51<sup>ST</sup> BRIGADE IRAQI ARMY BARRACKS  
AL HILLAH, IRAQ

**SIGIR PA-06-075**  
**JANUARY 29, 2007**

SUBJECT: Report on 51st Brigade Iraqi Army Barracks, Al Hillah, Iraq  
(Report Number SIGIR PA-06-075)

**Site Photo 5. Aluminum doors at front entrance to the barracks sleeping quarters**

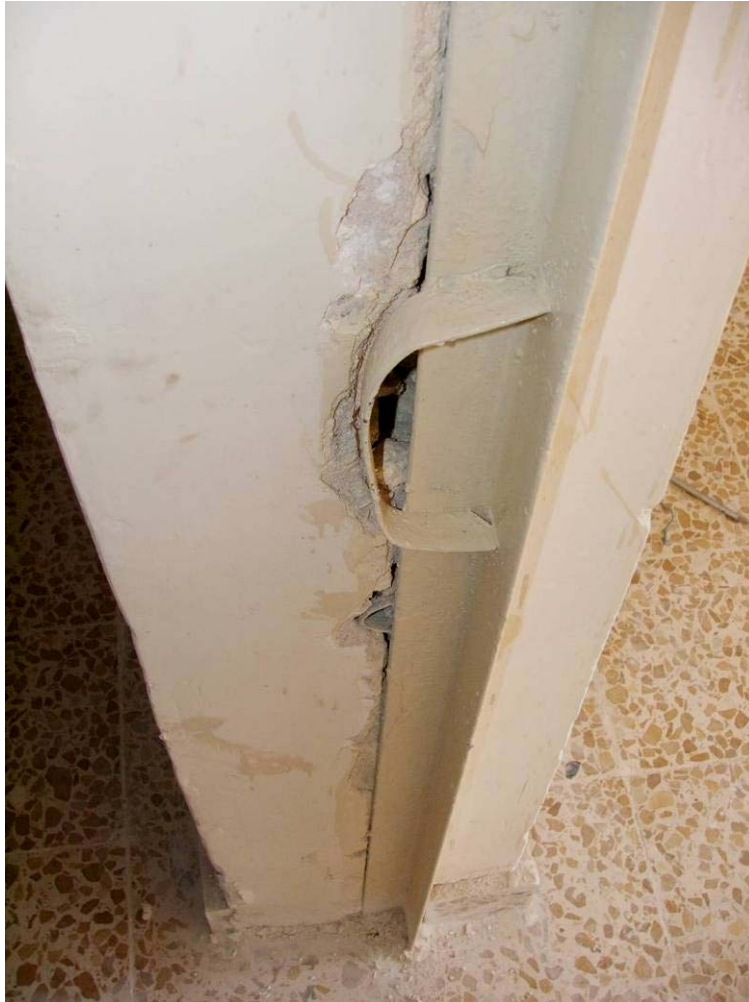
The SOW also required “good quality” aluminum windows and aluminum doors in the barracks sleeping quarters. In our inspection, we observed two sets of aluminum entry/exit doors in the sleeping quarters, one set of double doors serving as the front entrance, and a single door in the rear of the building. These doors did not appear to be “good quality,” especially considering the high traffic that a 75-man barracks will receive. Site Photo 5 shows the aluminum doors used for the entrance to the barracks sleeping quarters, and Site Photo 6 shows the rear entrance/exit door in one of the two barracks.

**Figure 1. Design detail for covered parking (sunshade)**

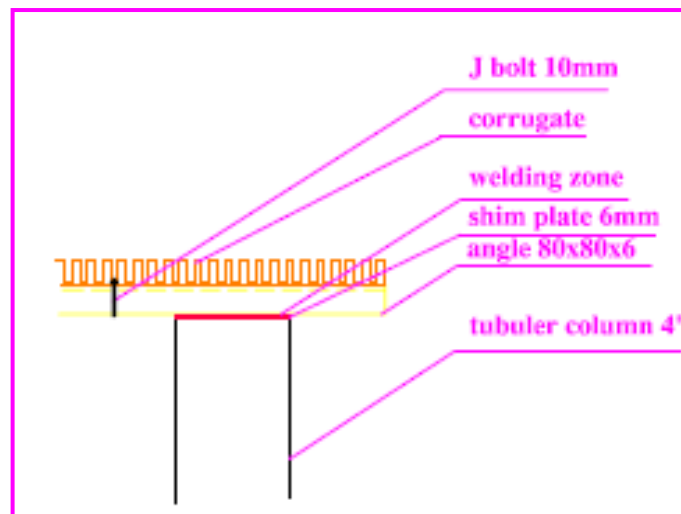
The design detail for the structural frame supporting the corrugated roof sheeting (Figure 1) showed an 80 x 80 x 6 angle supporting the roof sheeting. No units were provided for the angle, although it is assumed the dimensions are in millimeters. Figure 1 also shows the angle welded to a shim plate at the top of the column. There were no details provided on the type or size of weld or the type and thickness of the corrugated roof sheeting. The design also did not show any lateral cross bracing perpendicular to the angle support shown in Figure 1.

Site Photo 14 shows the actual welded angle connections at the bearing plate (i.e., shim plate) at the top of each tubular column, as well as, the lateral cross bracing. The roof sheeting material appeared to be a thin gage sheet metal, connected to the frame with J-bolts, as depicted in Figure 1.

**Site Photo 15. Torn sheeting at one end of the parking sunshade**

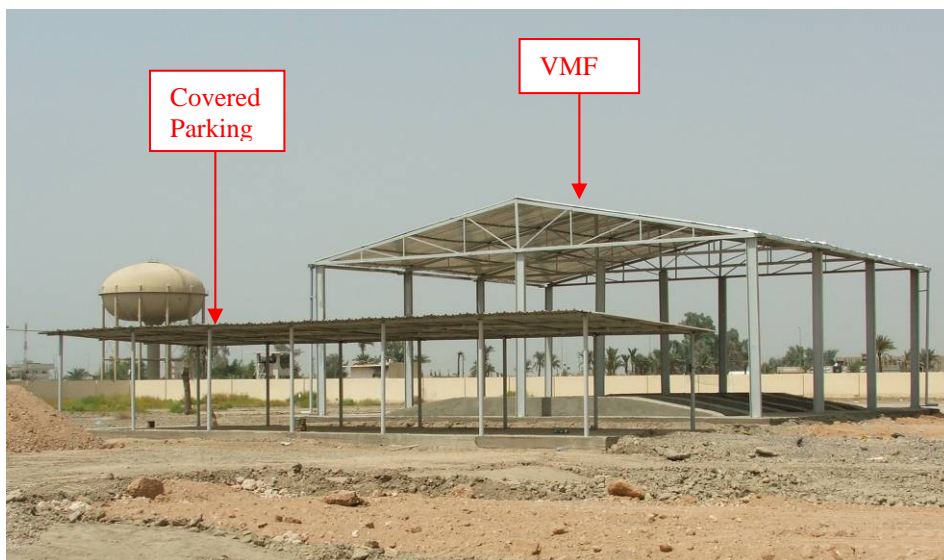
At one end of the sunshades, a portion of the metal sheeting was torn away at the corner (Site Photo 15). We also observed broken concrete at the base of one of the four inch tubular columns (Site Photo 16). Both of these items should be included in the punch list generated at final inspection.
